### ISO/IEC 11801-3

#### **AMENDMENT 1**

Information technology – Generic cabling for customer premises – Part 3: Industrial premises (standards.iteh.ai)

Figure 14 - Symbols for bulkhead connections

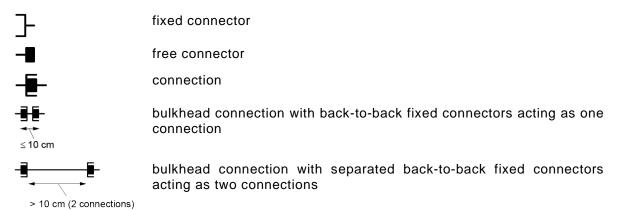
Replace subclause 1303/with the following standards/sist/d2edd7a2-e690-4b4c-bdea-dbf755c65527/iso-iec-11801-3-2017-amd1-2021

The symbols shown in Figure 14 define the number of connections in all end-to-end links.

NOTE Bulkhead mounted connections with fixed cable can have a variable length to accommodate the installation within the cabinet.

Figure 15 - Balanced 1-pair intermediate cabling models

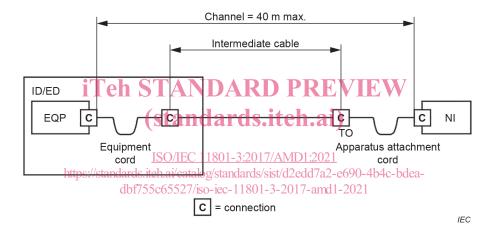
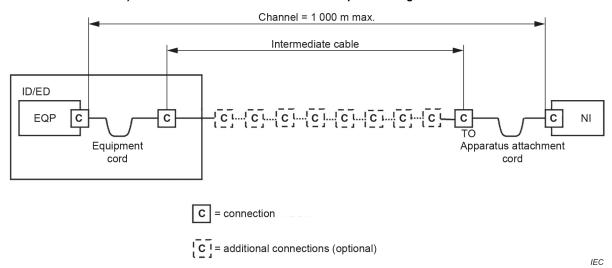
Add the following new subclause after 8.2.2.2:

Figure 15a) shows a 40 m balanced 1-pair channel (40 m interconnect – TO model). Figure 15b) shows a 1 000 m balanced 1-pair channel (1 000 m interconnect – TO model).

a) Interconnect - TO model balanced 1-pair cabling channel 40 m

b) Interconnect - TO model balanced 1-pair cabling channel 1 000 m with up to 10 connections

Figure A.2 – Combined structure of generic and industrial cabling system using an IID with optional ED

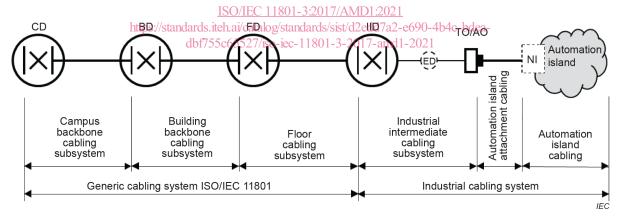
(standards.iteh.ai)
Replace Figure A.2 with the following new figure:

At the end of the paragraph after Figure A.2, add the following new sentence:

The industrial intermediate cabling may include an edge distributor (ED) to accommodate active equipment to allow transition from balanced 4-pair cabling to balanced 1-pair cabling.
